BULLETIN # 0 4 R

PROJECT: Harrison Recreation & Community Center – PHASE 2
Harrison, NY

RE: Additional Work from Phase 1 to Phase 2 Contractor

A-201

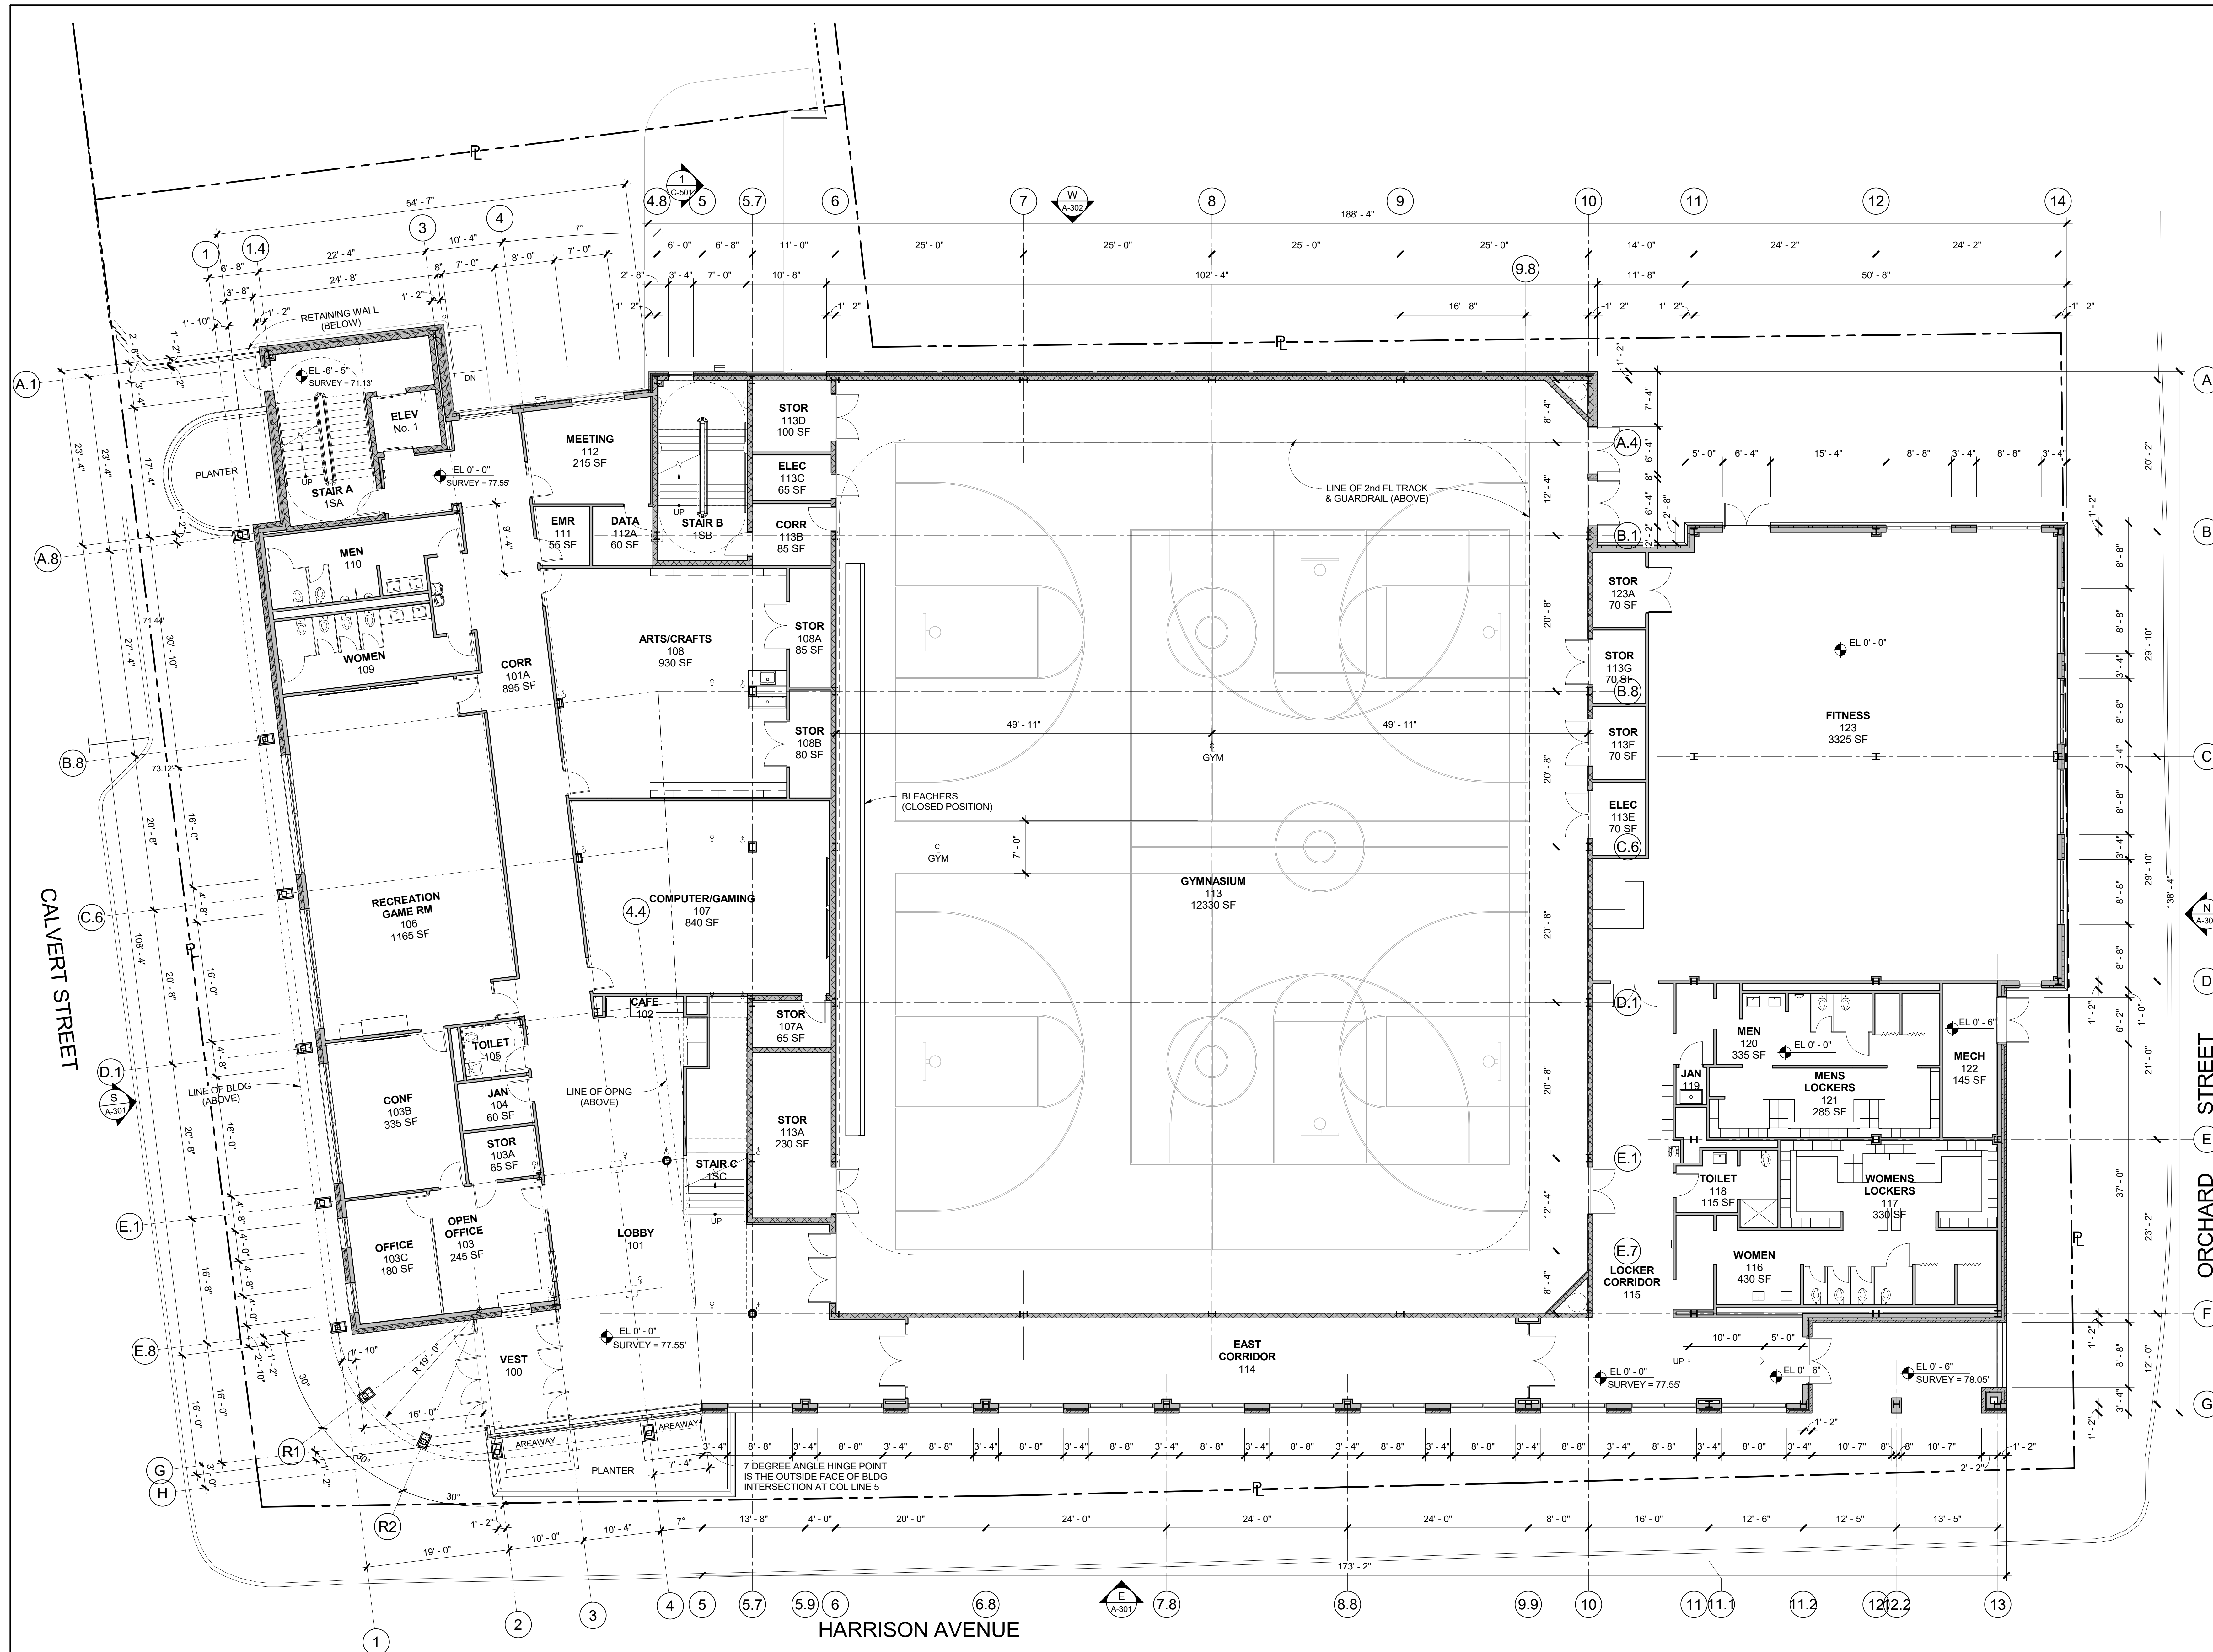
Provide 3 under slab drain pipes running east to west directly under the slab per the Skylands report dated February 5, 2025. Contractor to core the side of the trench drain to accept the added under slab drain pipes. Provide striping to replace the eliminated curb at the perimeter of the Parking area. Provide additional gravel below slab, 6" at occupied space and walkways and approximately 12" at the Parking Area. Contractor to delete the vapor barrier below the Parking Area only. Please note to the south of Stair B entrance ramp to pitch down to trench drain. Ref Dwg A 201.

Stairs A, B, and D have been modified due to the change in slab elevation at the Lower Level. Contractor to increase the gravel base by 6" as noted above. The stairs contain one less riser and tread and the railing length has been reduced. Refer to Drawings A201 and A701.

1 FIRST FLOOR PLAN PHASE 1
SCALE: 1/8" = 1'-0"

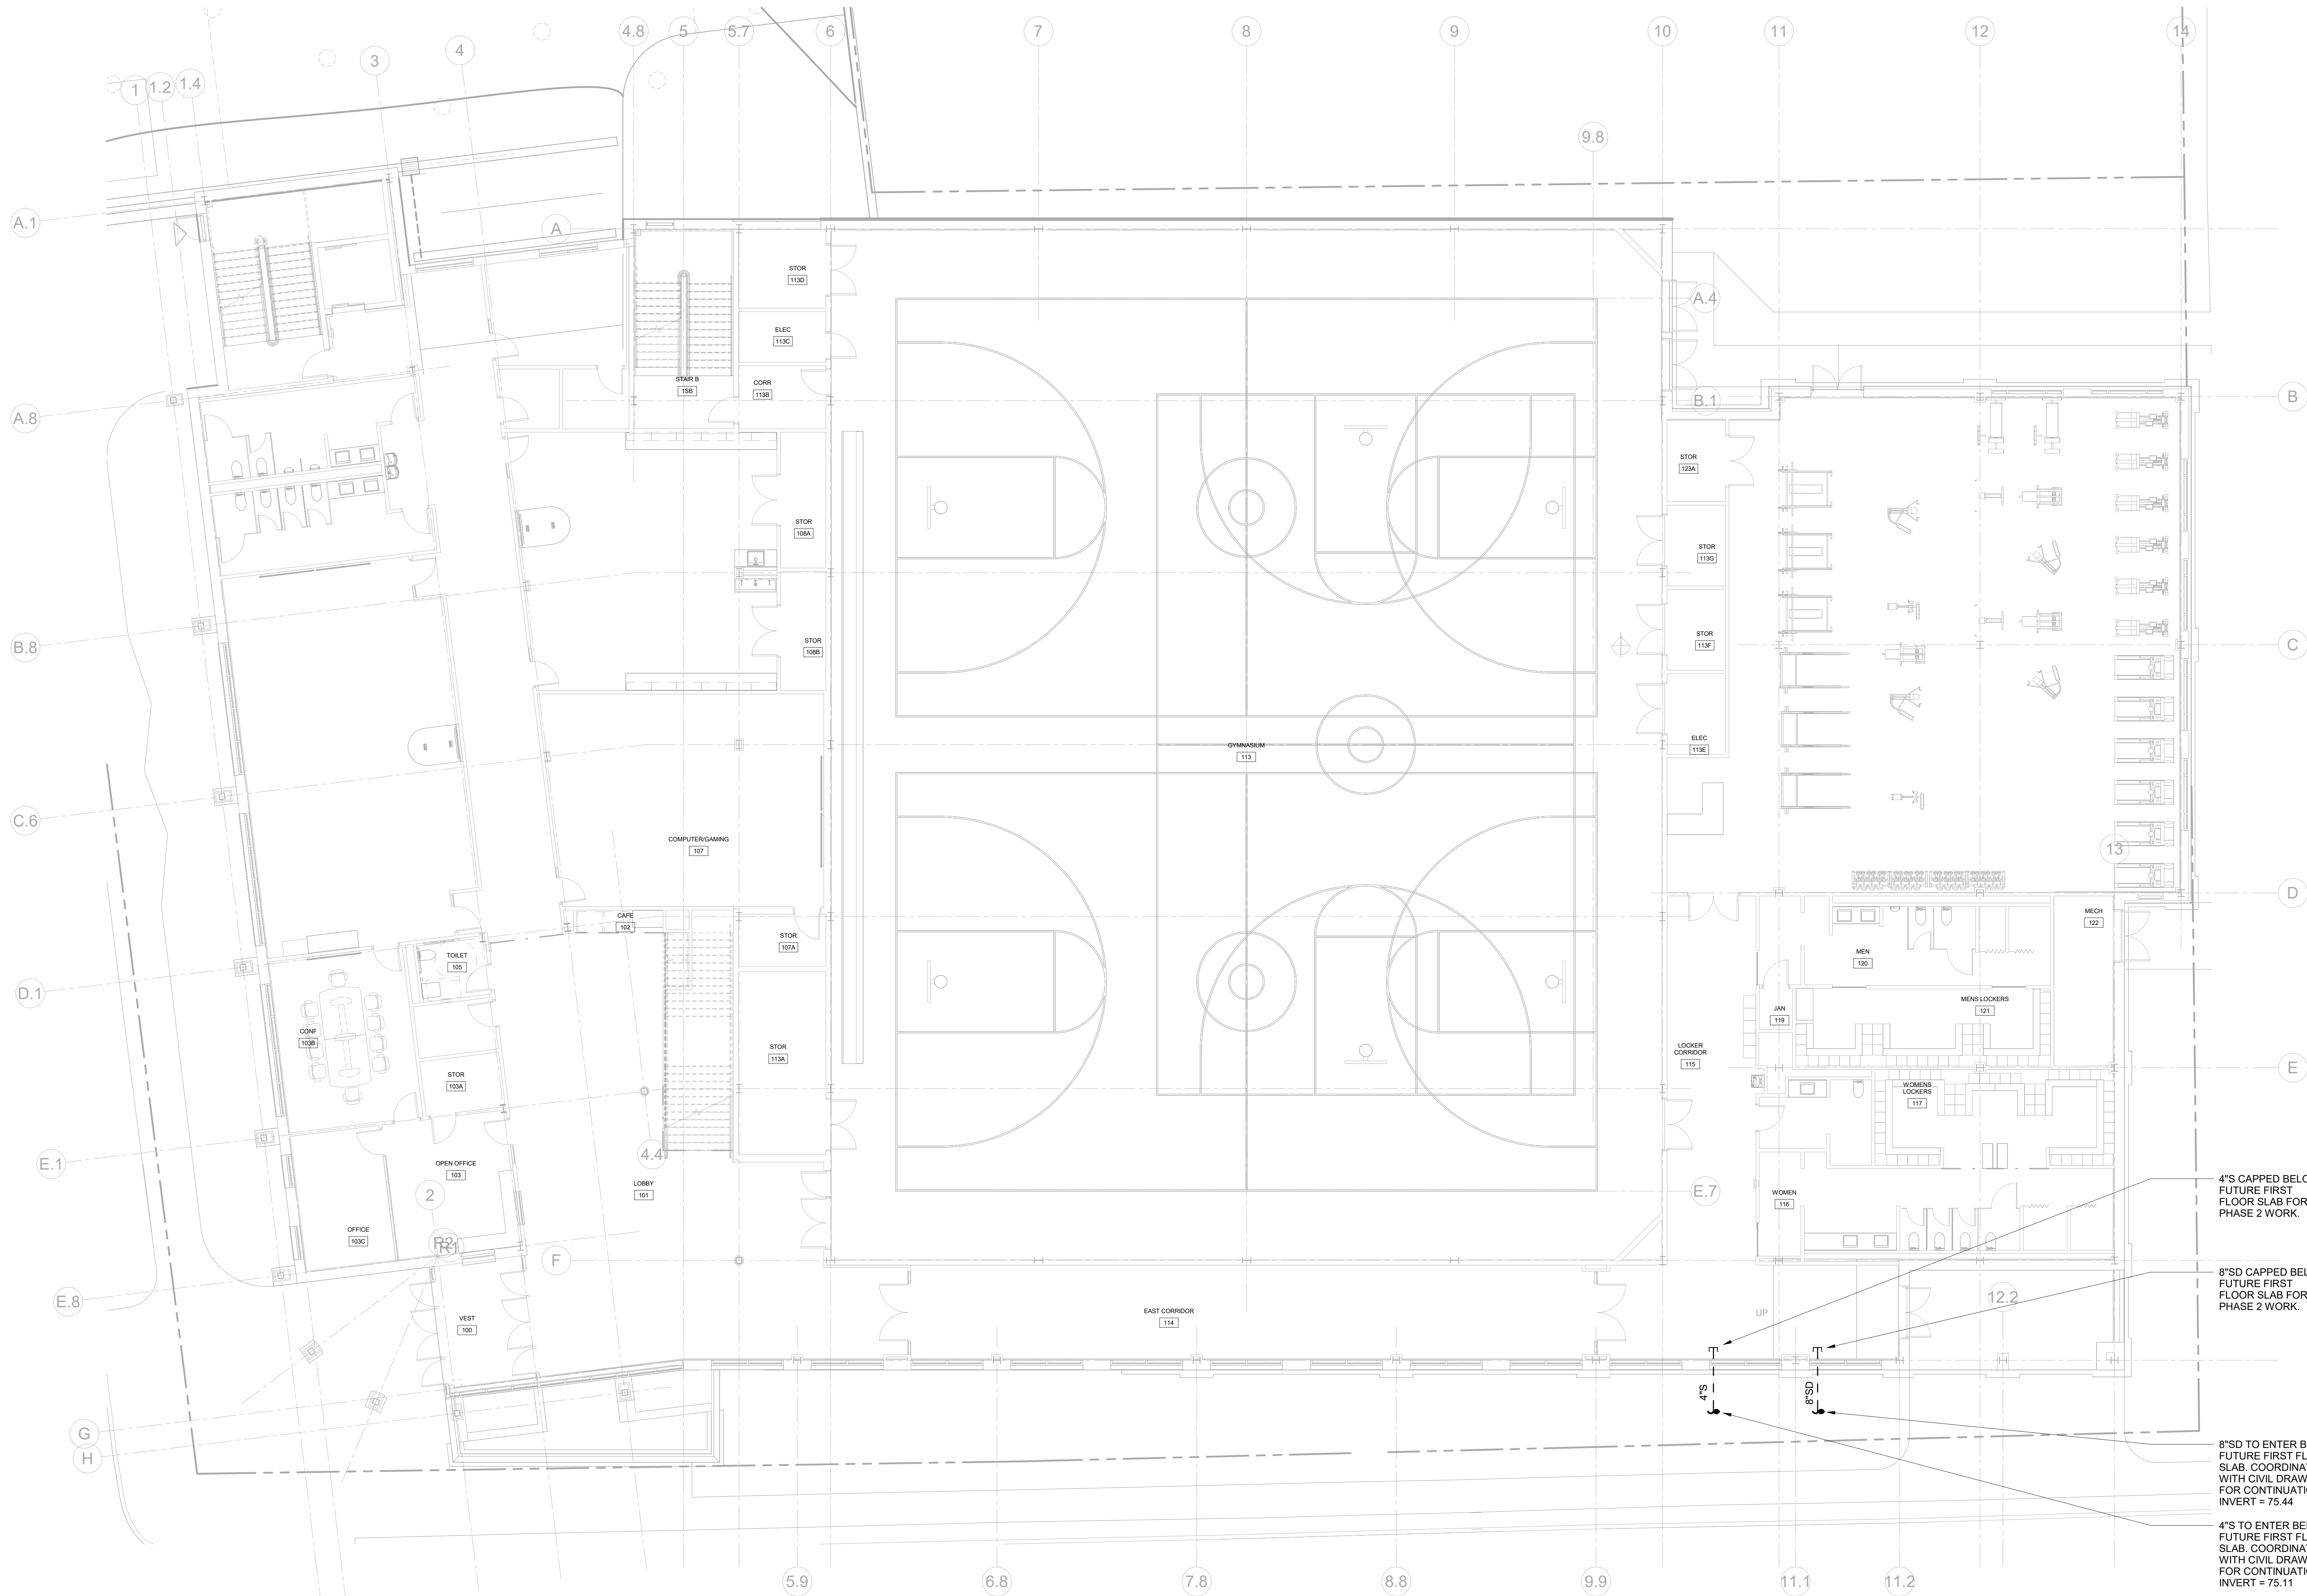
Lower Level slab elevations raised from -12'-0" and -12'-6" below First Floor to 11'-6" below First Floor. Phase 2 Contractor to provide additional 6" of gravel below slab at all areas. Phase 2 Contractor to provide vapor barrier at all areas except Parking Area B01. Contractor to provide Domestic and Fire Service valves not installed in Phase 1. Ref Dwg Phase 1 M-101.
